## **Spokane Park Board Agenda**

## Design-Build Change Order Form

Change Order Number: <b>3</b>	Change Order Effective Date: <b>5/11/18</b> (date when executed by both parties)
Project: <b>PAVILION DESIGN BUILD PROJECT</b>	Design-Builder's Project No:
	Date of Agreement: <b>APRIL 13, 2017</b>
Owner: <b>CITY OF SPOKANE - PARKS &amp; RECREATION DIVISION</b>	Design-Builder: <b>GARCO CONSTRUCTION, INC.</b>

**PAVILION DESIGN BUILD PROJECT**  
**Change Order #3**  
**Backup Documentation**

DRAWING NUMBER  
**M-111a**  
REVISION NO: 8APR18

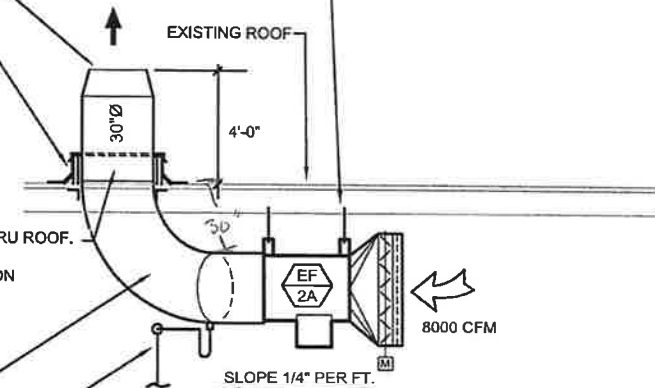
Contractor requested to add an exhaust fan ducting and louver in the mechanical room for emergency ventilation

Stantec had to make a change to the ventilation system design to ensure compliance with the 2015 International Mechanical Code and prevent a possible positive pressure condition in the refrigeration machine room. Attached are revised drawings reflecting those changes. These should be used for permit and construction.

ELECTRICAL:  
NEW EXHAUST FAN SHALL BE CIRCUITED FROM H-19,21,23. PROVIDE  
NEW 15A/3P CIRCUIT BREAKER. PROVIDE NEW BRANCH CIRCUIT TO  
EXHAUST FAN. BRANCH CIRCUIT SHALL BE (1) 3/4" EMT CONDUIT, (3)  
#12 AWG, (1) #12 AWG GND. FIELD COORDINATE EXACT BRANCH  
CIRCUIT ROUTING. CONNECT BRANCH CIRCUIT TO FACTORY  
PROVIDED DISCONNECT.

CONTROL:  
PROVIDE WITH NEW WALL SWITCH FOR ON/AUTO OPERATION.  
LOCATE SWITCH NEAR WEST ENTRANCE DOOR. FAN SWITCH SHALL  
NOT HAVE AN OFF POSITION. IN AUTO MODE, FAN WILL BE  
CONTROLLED BY EMERGENCY VENTILATION CONTROL SYSTEM FOR  
REFRIGERATION EQUIPMENT.

8000 CFM THRU 24"Ø DISCHARGE  
NOZZLE = 2500 FPM

FAN SUPPORTS CLAMPED TO  
EXISTING ROOF FRAMING.  
APPROX. WT. FOR FAN, DUCT  
& DAMPER = 600 LB.

NEW ROOF CURB WITH  
SHEET METAL CAP FOR  
DUCT PENETRATION.  
MATCH EXISTING ROOF  
FLASHING AND  
COUNTER FLASHING.  
TYPICAL TWO PLACES.

PROJECT TITLE:	RIVERFRONT PARK SOUTH BANK WAYFINDING 100% DESIGN SUBMITTAL - PACKAGE 1
SHEET TITLE:	LANDSCAPE TYPE 1 WAYFINDING DEVICE DETAILS

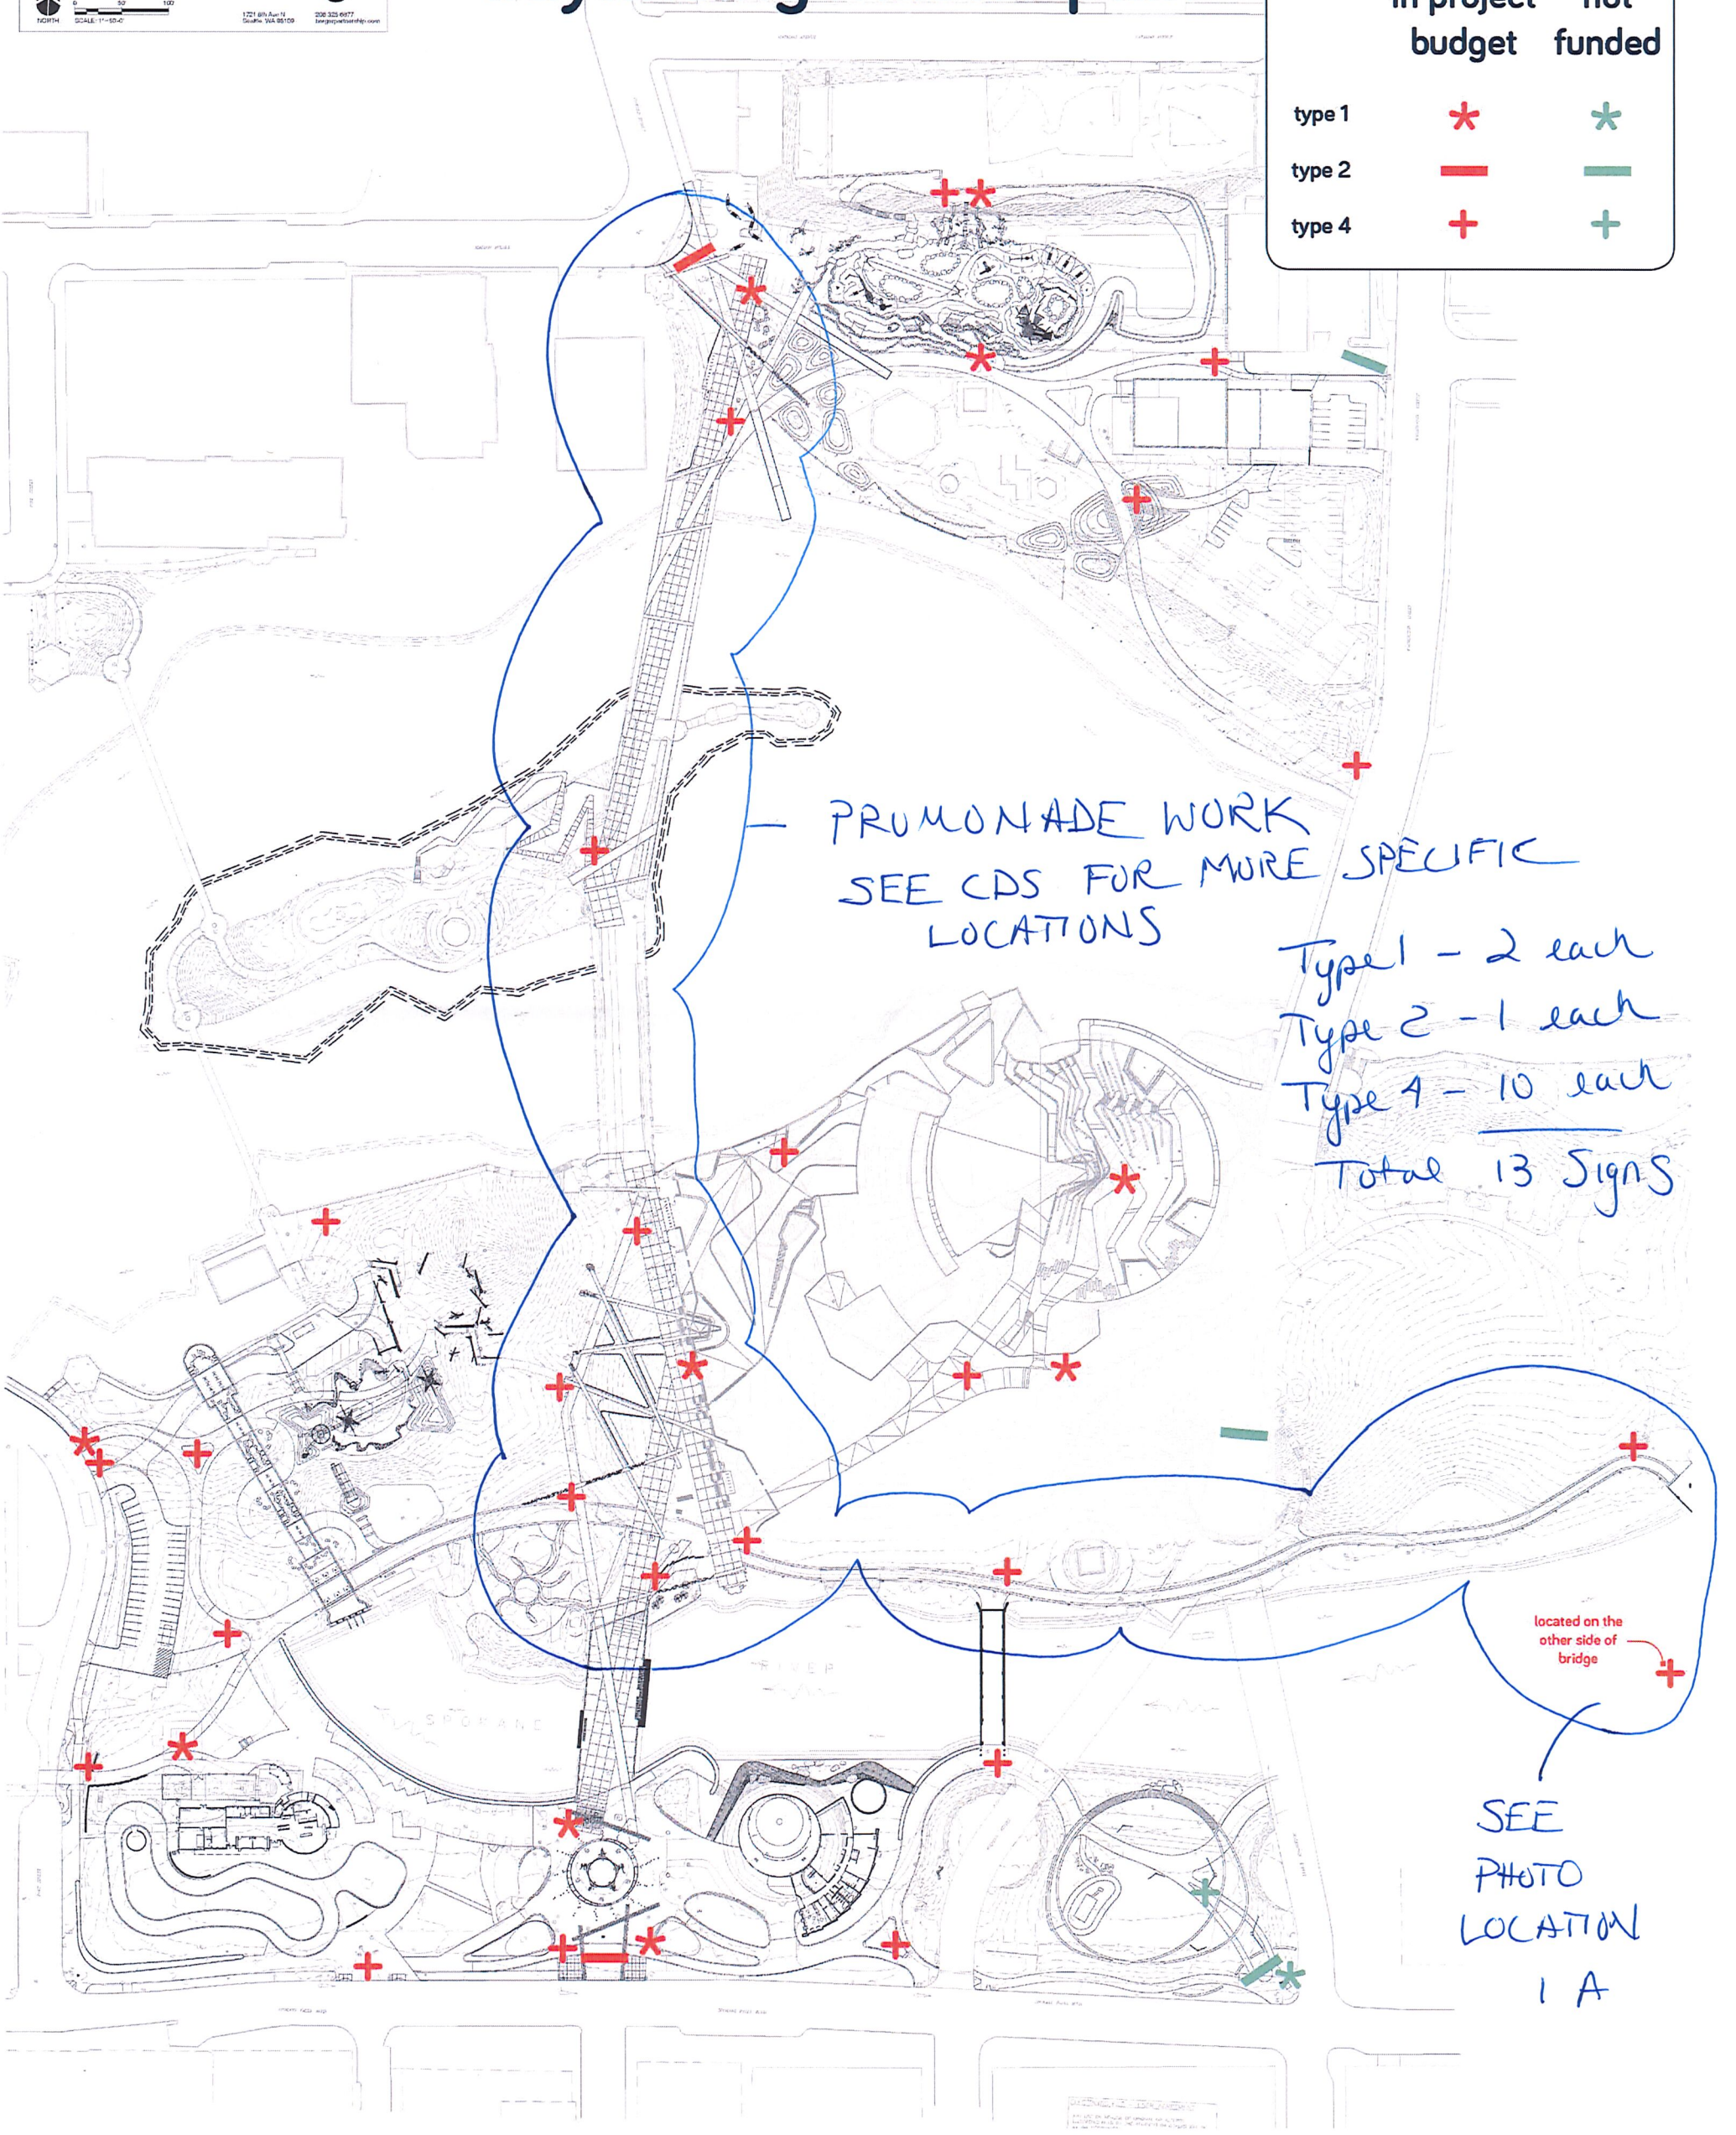
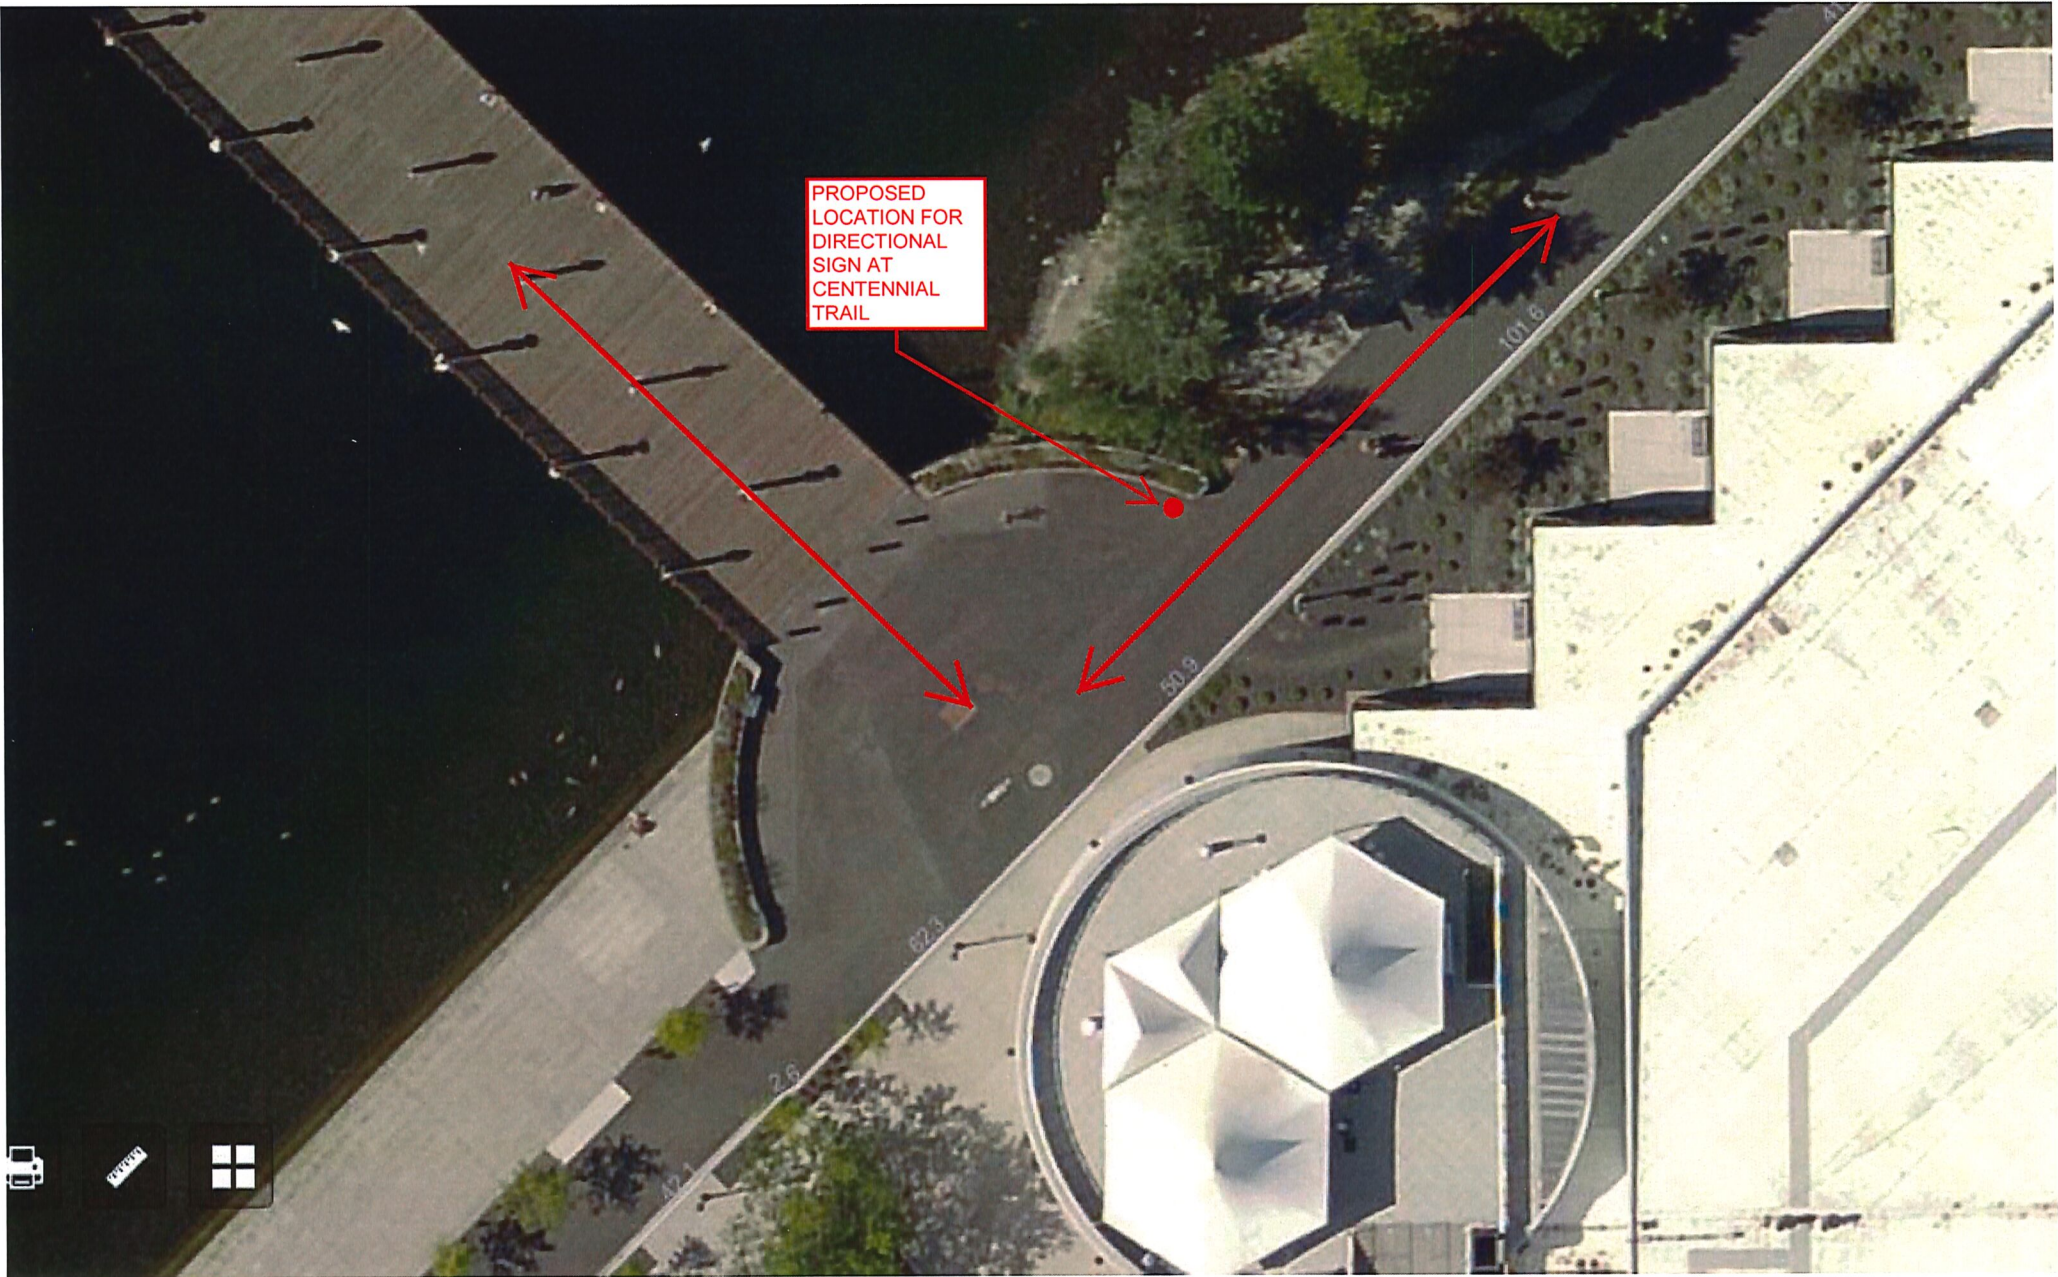
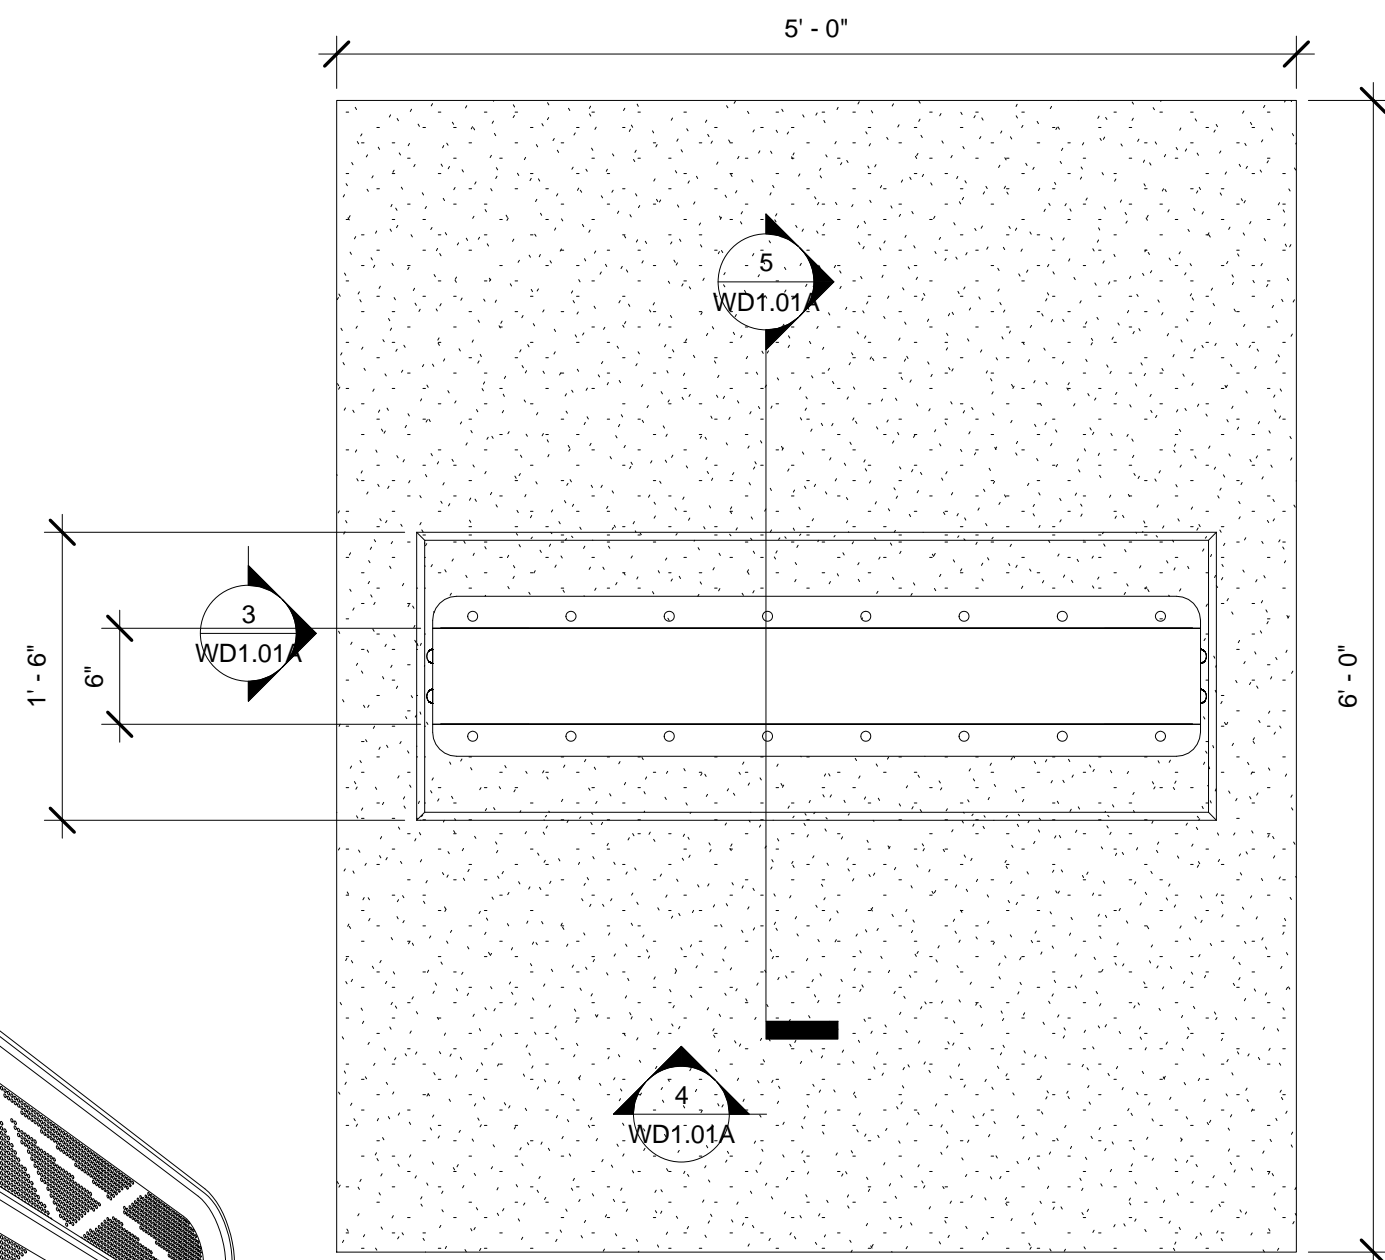
**Description:** Provide pricing to place the footings for the 13 signs as defined by the attached Wayfinding Master Plan, before the promenades finishes are installed. The requirements for the sign types and required footings are shown on the attached detail drawings from the South Bank Wayfinding package. The signage and graphics part of the sign will be issued as a change at a later date.
